RS-03-064

U. S. Nuclear Regulatory Commission
Attn: Document Control Desk
Washington, DC 20555-0001Braidwood Station, Units 1 and 2
Facility Operating License Nos. NPF-72 and NPF-77
NRC Docket Nos. STN 50-456 and STN 50-457Byron Station, Units 1 and 2
Facility Operating License Nos. NPF-37 and NPF-66
NRC Docket Nos. STN 50-454 and STN 50-455

Subject: Request for a License Amendment to Revise the Pressurizer Safety Valves Lift Settings

Figure 1

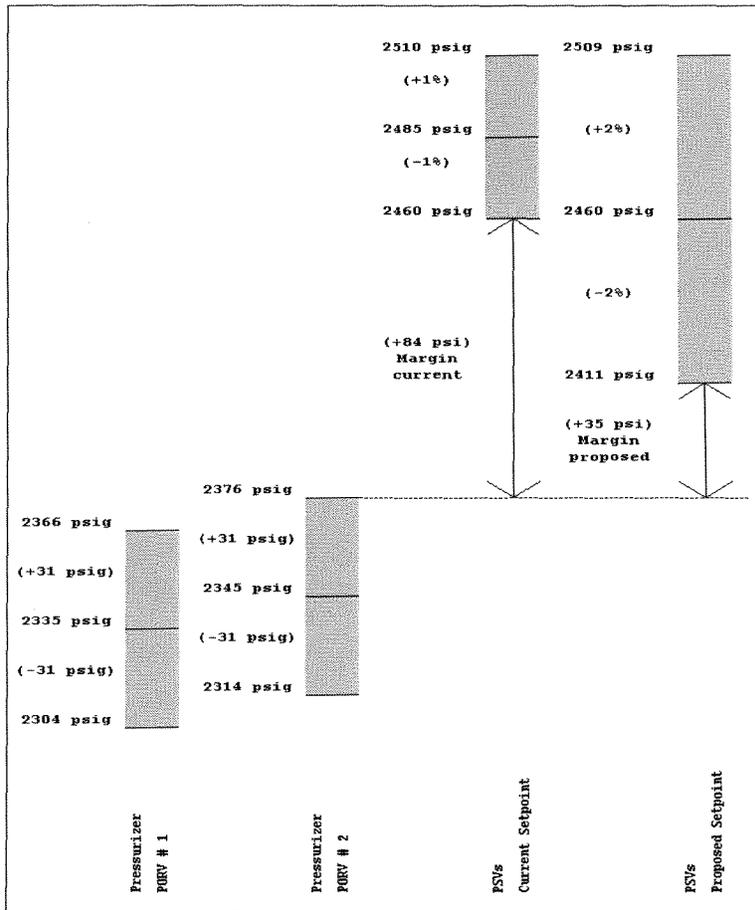
challenges to the PSVs. The impact of the proposed change on the adequacy of margin between the opening of the pressurizer PORVs and the opening of the PSVs was evaluated. The pressurizer PORVs are designed to lift prior to the PSVs. At Braidwood, the two pressurizer PORVs have staggered setpoints of 2335 psig and 2345 psig. The calculated uncertainty associated with opening the pressurizer PORVs was determined to be ± 31 psig based on a recent design change that removed the compensated pressure signal from one of the pressurizer PORVs. That is, currently at Braidwood, both pressurizer PORVs receive input from uncompensated pressure signals. Conservatively applying the pressurizer PORV instrument uncertainty (i.e., ± 31 psig) to the nominal actuation setpoint of the pressurizer PORV with the highest setpoint (i.e., 2345 psig), results in an actuation band between 2314 and 2376 psig. When compared to the current PSV lift setpoint and associated setpoint tolerance (i.e., 2485 psig $\pm 1\%$ resulting in an actuation band of 2460 and 2510 psig), the margin between the highest possible actuation of a pressurizer PORV (i.e., 2376 psig) and the lowest possible actuation of a PSV (i.e. 2460 psig) is 84 psi. When compared to the proposed PSV lift setpoint and associated setpoint tolerance (i.e., 2460 psig $\pm 2\%$ resulting in an actuation band of 2411 and 2509 psig), the margin between the highest possible actuation of a pressurizer PORV (i.e., 2376 psig) and the lowest possible actuation of a PSV (i.e. 2411 psig) is 35 psi. Refer to Figure 1 below.

Although the proposed change results in a reduction in the margin between opening the pressurizer PORVs and opening the PSVs, the resulting margin is still sufficient to ensure that the PORVs will actuate prior to the PSVs.
